Staff Report

To: Salt Lake City Planning Commission
From: J.P. Goates, 801-535-7236, jp.goates@slcgov.com
Date: January 13, 2015
Re: PLNSUB2015-00218 326 W Reed Ave Marmalade Courtyards Planned Development;
PLNSUB2015-00219 Marmalade Courtyards Preliminary Subdivision

Planned Development and Subdivision

Typical road way sections

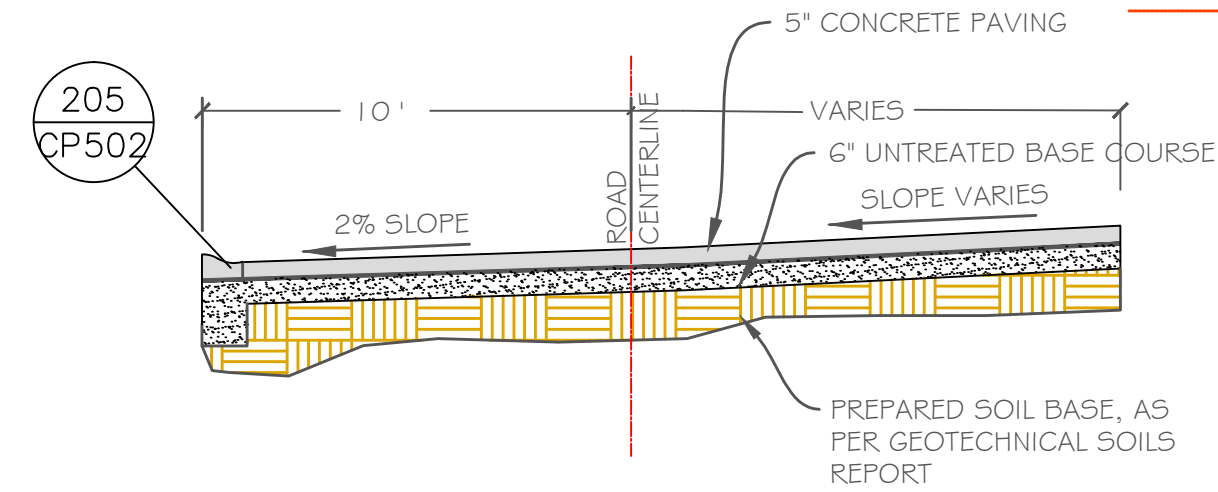
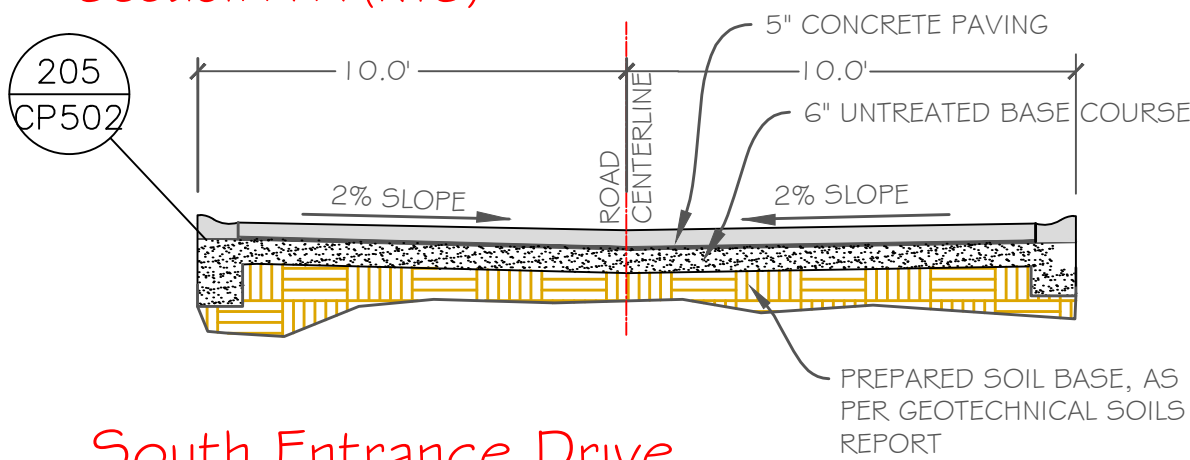
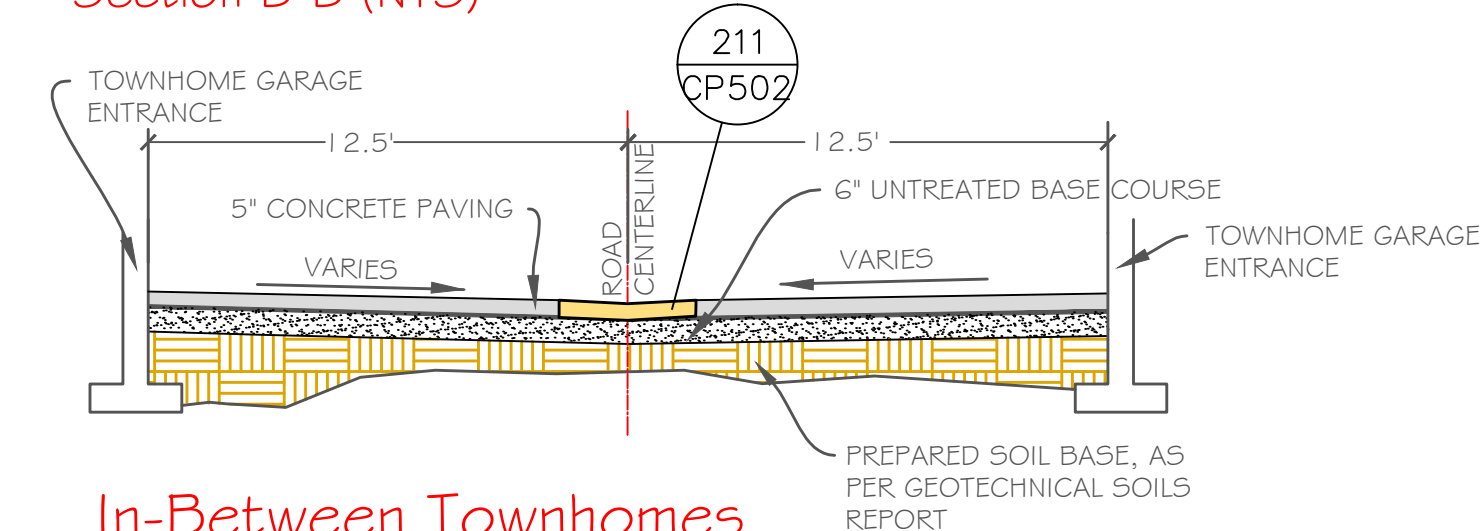
The City generally requires 50 feet of right-of-way dedication for a residential street. The nature of the lots and designed access to multiple units as presented would not allow for 50 feet width. The existing access from 800 North behind the existing buildings is only 40 feet. The proposed street access is 20 feet from curb to curb. Due to this exception, the applicant is applying for consideration of reduced width private street per 20A.12.010 General Regulations and Standards for access to public streets. The proposed private street would be accessed via 800 North or Reed Ave., providing vehicle access to parking garages, covered parking and guest parking. The street will maintain a uniform 20 foot width throughout with a 4 foot sidewalk on one side to provide access to all units via sidewalk or street crossing. The proposed 20 foot width would accommodate the narrow lot access and maintain adequate width for two way vehicle movement and emergency access and require that no parking signs be posted on the street. The relevant City departments have reviewed the street proposal and have provided comments regarding the proposed private street in Attachment J. The Transportation Division also identified issues with angled parking being too close to the sidewalk and the requirement for multi-family developments to have bike racks and ADA parking spaces. These issues and other transportation division requirements will need to be addressed as part of the approval process.

The 20' drive access would not meet standards for a public roadway for a number of reasons. The plat has a note toward the bottom that calls out a "Dedicated Public Access Roadway"; I'm not sure this is the proper terminology. There is not enough information to determine if the minimum parking requirements are met for all units and if the garages provide the required parking space dimensions. For single family attached dwellings the minimum parking requirement is two parking spaces per dwelling unit and it is slightly different for multi-family residential, which is 2 spaces for 2 bedroom unit, 1 space for a 1 bedroom unit, ½ space for a studio. There are seven angled parking spaces near the north drive; the parking space farthest to the north is not permissible because a vehicle would need to back up over the sidewalk while pulling out. In the case of multi-family developments, bike racks and ADA parking spaces are generally required; none are shown on plans.

Condition: Private street shall be signed with “no parking” signs and is subject to the Salt Lake City Transportation Division approval and applicable department requirements for private street access must be met.
